Comments on the Interim Report Concerning the Maryland RPS By the Future of Energy Initiative

Tasked to evaluate the Maryland RPS¹, the PPRP is to be complimented for its effort to come to grips with a complex, confusing and politically charged challenge. In support of the Interim Report Concerning the Maryland RPS (Report), we offer the following comments:

PJM wind capacity factors

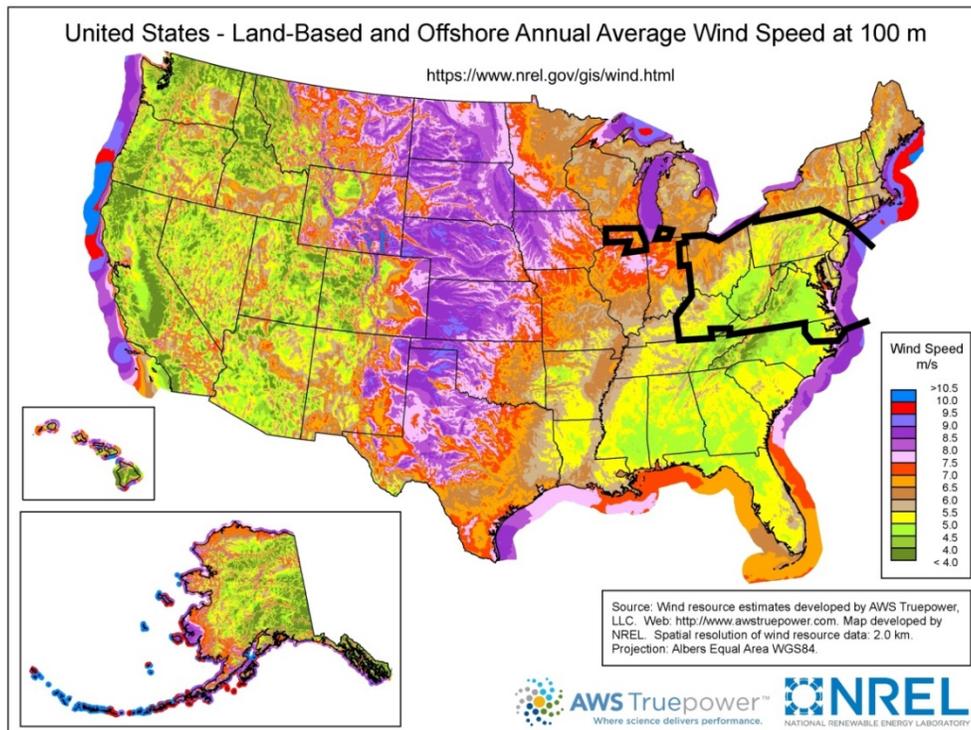
One key assumption in the EXETER calculation is wind Capacity Factor (CF); the amount of electricity produced over the whole year divided by the amount that would have been produced if the wind turbines were able to generate rated power 100% of the time. PJM reports a system level CF for 2017 of 27.6%⁴ with a 10 year average of 27.8% and no trend (note #15 at the end of these comments). The lack of trend over the past decade shows that any turbine technology improvements over the past decade have been small compared to other (probably system) factors. The PJM CF includes turbine design, wind resource, maintenance downtime, wakes, imperfect siting, imperfect setup, aging etc. as well as system constraints and losses.

PPRP should reconcile these numbers, why does the EXETER estimate of projected renewable generation significantly exceeds the PJM metered renewable generation. We note that the EXETER approach is a theoretical technology number assuming 100% utilization and no system constraints or losses. There appears to be no validation or verification. The PJM number is a practical system measurement of the amount of renewable energy delivered to the grid.
